Stage 1 Road Safety Audit

Proposed Works to Castlegar Road / Bóthar An Choiste (L5041) Road Junction, Castlegar Village, Galway

On behalf of Galway City Council

April 2022

3.2.3 See-through to former road

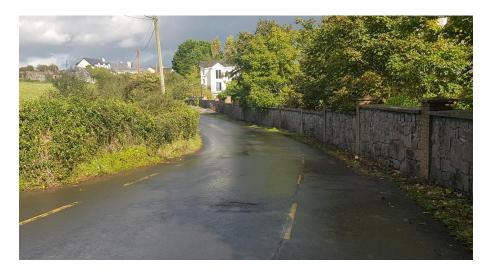
Problem: The existing Castlegar Road to the west of the proposed junction remains and is shown dotted on the drawings.

Hazard: Road users may errantly believe this road is available for use and strike the new kerb.

Recommendation: Break out and landscape the redundant element of road.

3.2.4 Road Serving Access to Future Development

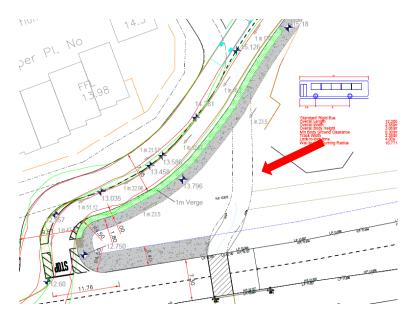
Problem: The existing road leading to the future development lands is narrow and incorporates sharp bends with poor forward visibility and no footpaths.

Hazard: The future developments are likely to generate additional vehicular and pedestrian traffic on this road. Head on impacts between vehicles or pedestrian strikes may result.

Recommendation: Upgrade the road to provide adequate forward visibility, carriageway width and pedestrian facilities.

3.3.2 Bothar An Choiste (L5041) Central Median

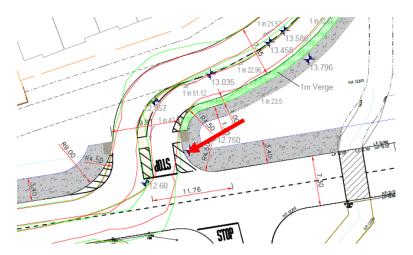
Problem: There is an existing raised central median in the L5041 to the west of the proposed junction. The proposals include for removal of the existing right turning lane and associated hatch markings that lead up to this median.

Hazard: L5041 traffic may strike the raised median.

Recommendation: Remove the raised median.

3.3.4 Bothar an Choiste (L5041) Road Markings

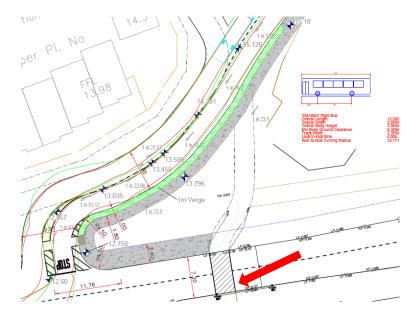
Problem: There are road markings proposed at a location for pedestrians to cross Bothar an Choiste (L5041) that are non-standard.

Hazard: Motorists may be confused as to what to do here and slow down stop in the carriageway and be rear-ended.

Recommendation: Ensure any road markings comply with the Traffic Signs Manual.
